Agenda Item: 8
 Case # SI-2021-01712
 Project # PR-2021-006115
 February 9, 2022

Supplemental Staff Report to November 10, 2021 Staff Report

| Request | Certificate of Appropriateness for New Construction |
| Address/Location | 912 Forrester Ave. NW |

SHED LAYOUT

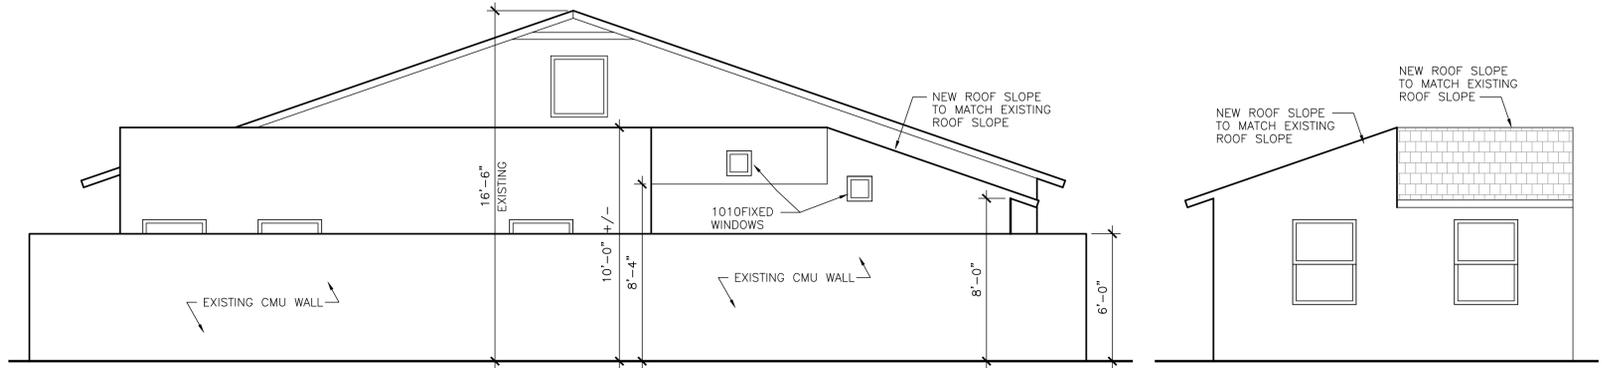
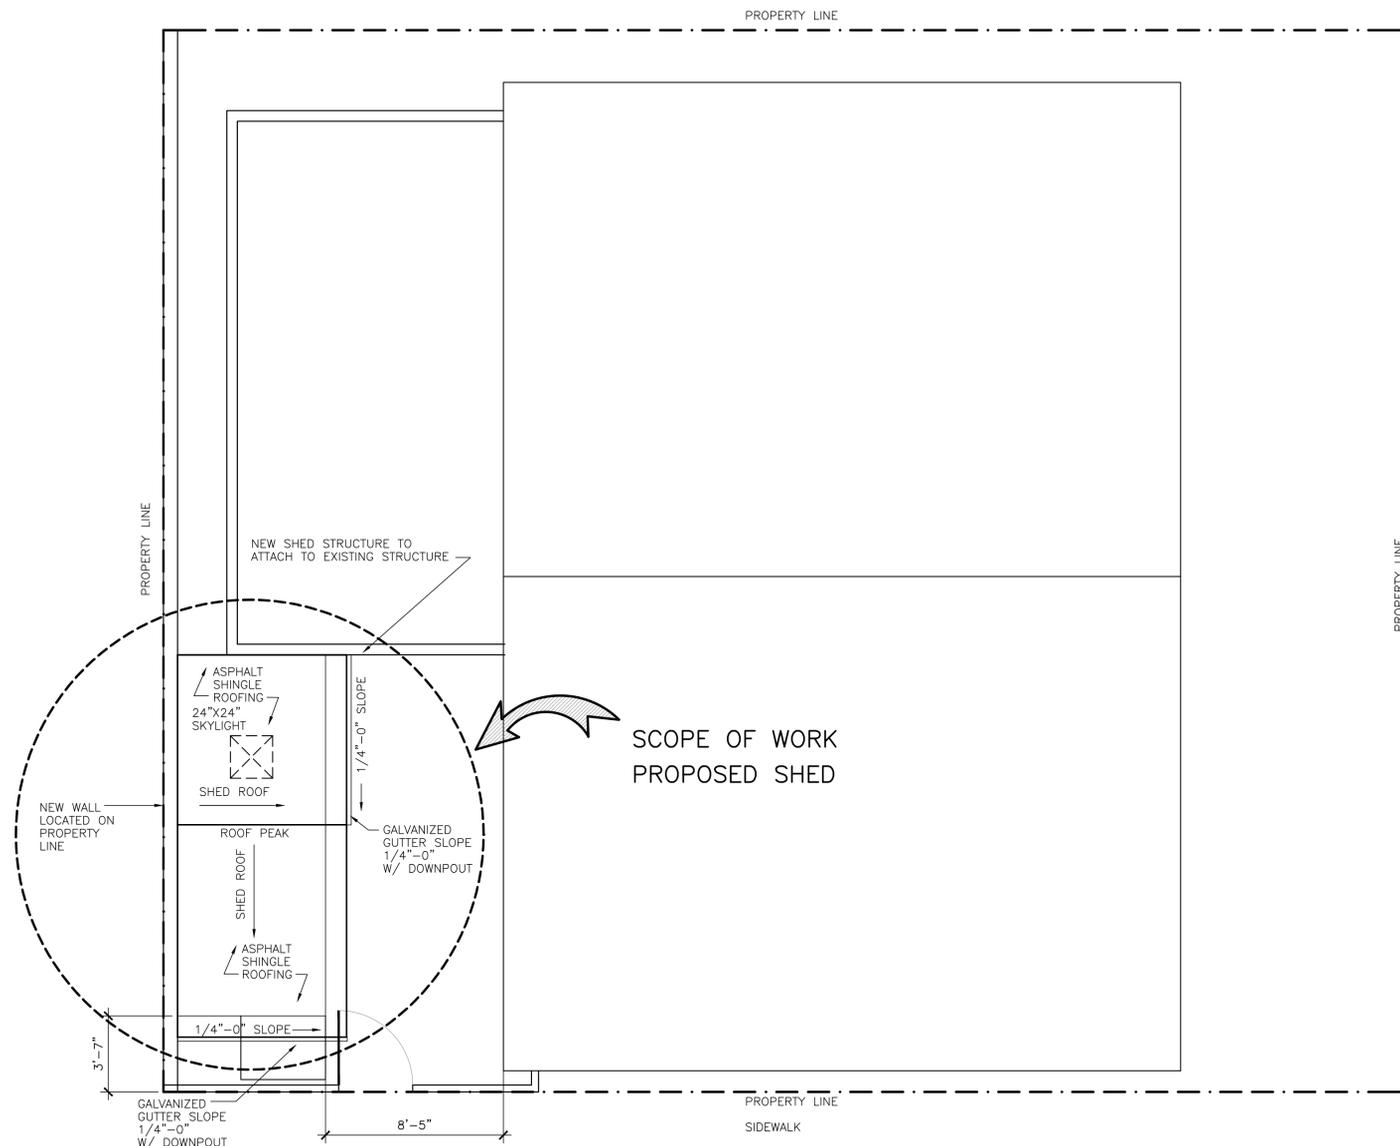
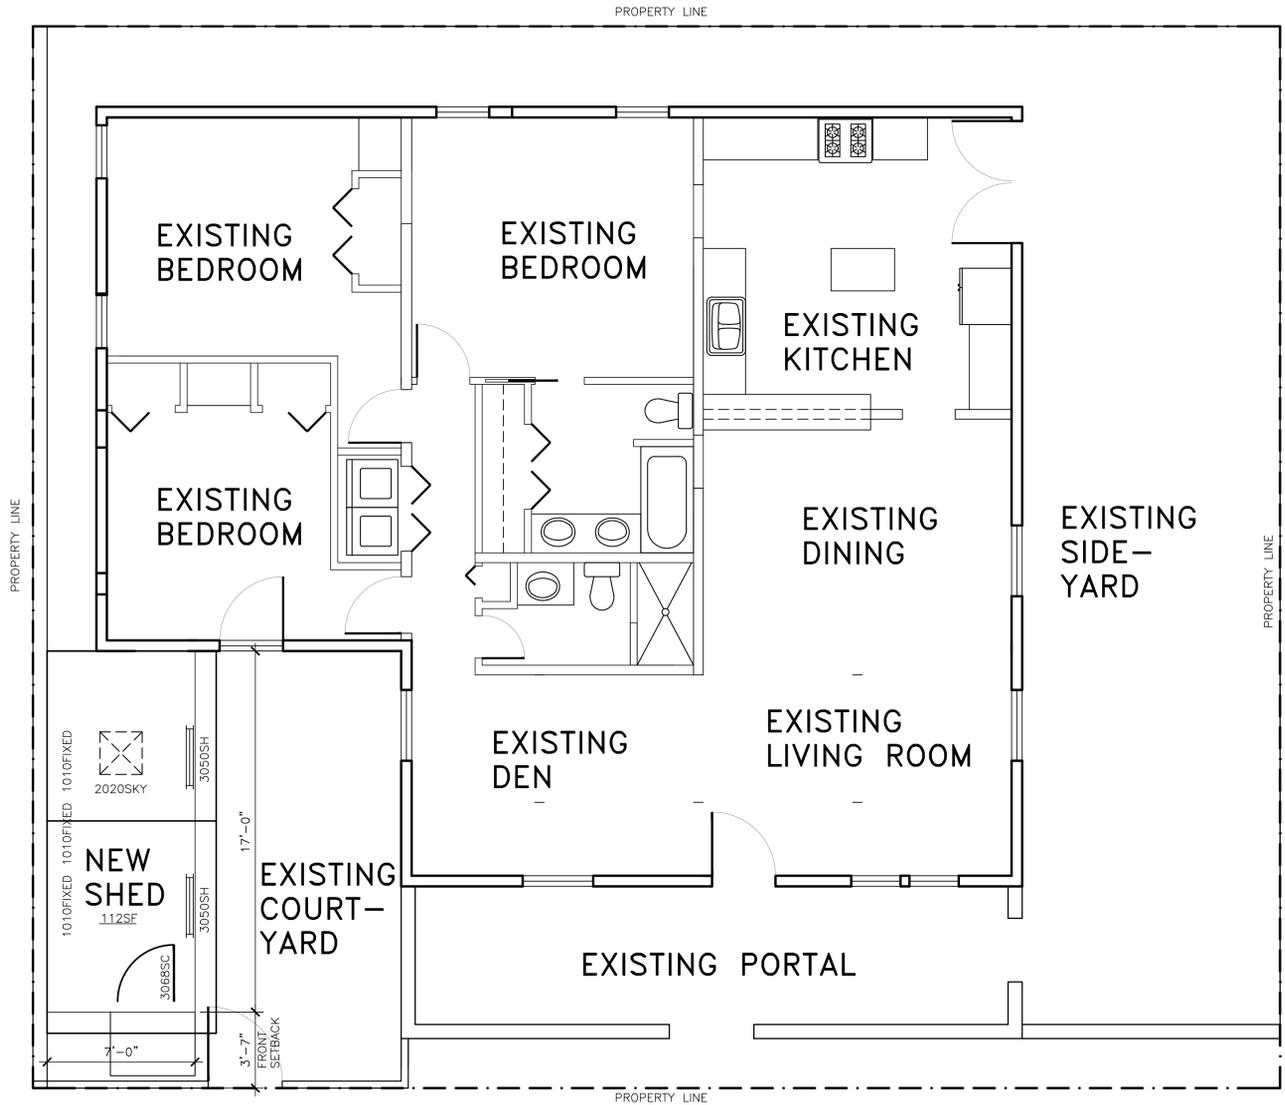
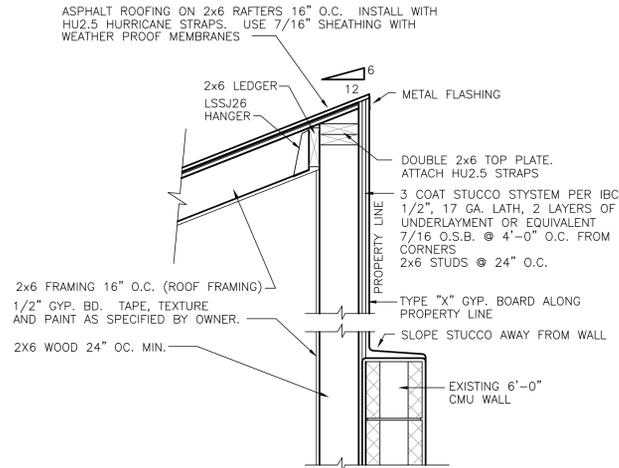
The applicant is proposing for the new shed structure to attach to the existing main house. The shed layout sheet (A1) reveals that the shed will be 7'0" x 17'-0" for a total of 119 square feet. The proposed height of the shed will be 10'-0".

The applicant is proposing asphalt shingle roofing that will match the existing roof in materials and slope (6:12 pitch) and a 24" x 24" skylight. A stucco finish will be applied to the shed that will match the stucco finish of the main house. The exterior wall of the main house will be framed out to allow for the new storage shed to be attached to the house.

The accessory shed is located in the side/front yard, in direct violation of the guidelines but the applicant has been granted a waiver by the Zoning Hearing Examiner for the 5' foot setback.

NEW SHED CONSTRUCTION
JOSH AND MOLLY KRAUSE
 912 FORRESTER AVE, NW ALBUQUERQUE
 NEW MEXICO
 JOB TITLE:
WORKING DRAWINGS
 SHEET TITLE:

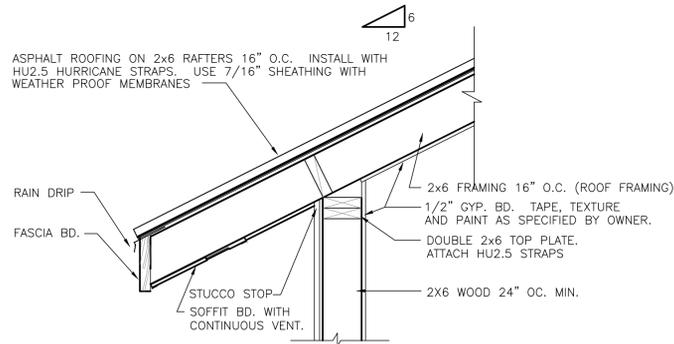
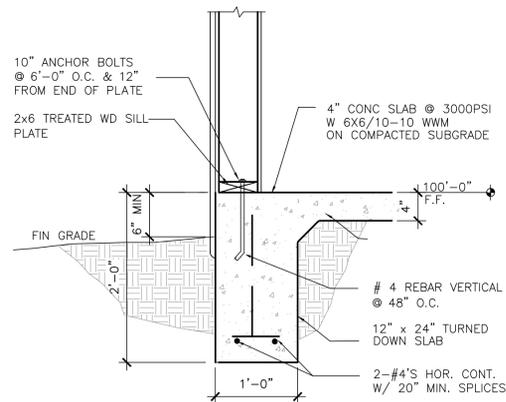
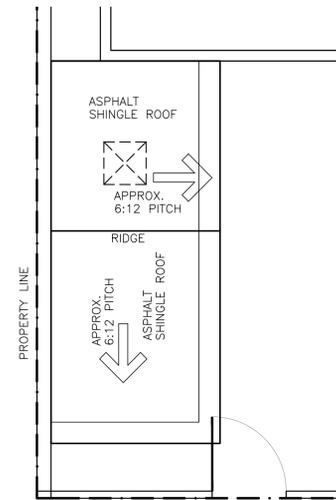
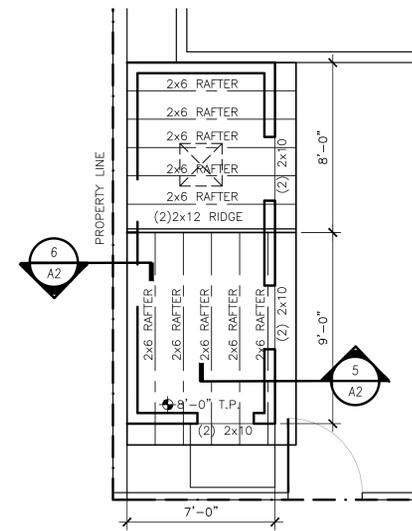
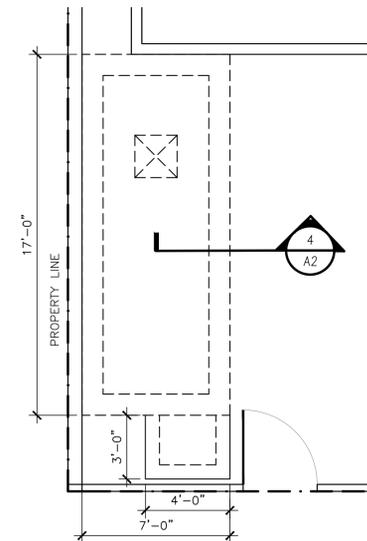
The applicant is proposing a stucco finish that will match the stucco finish of the main house. Frame construction is being proposed that will match the main house (see Sheet A2).
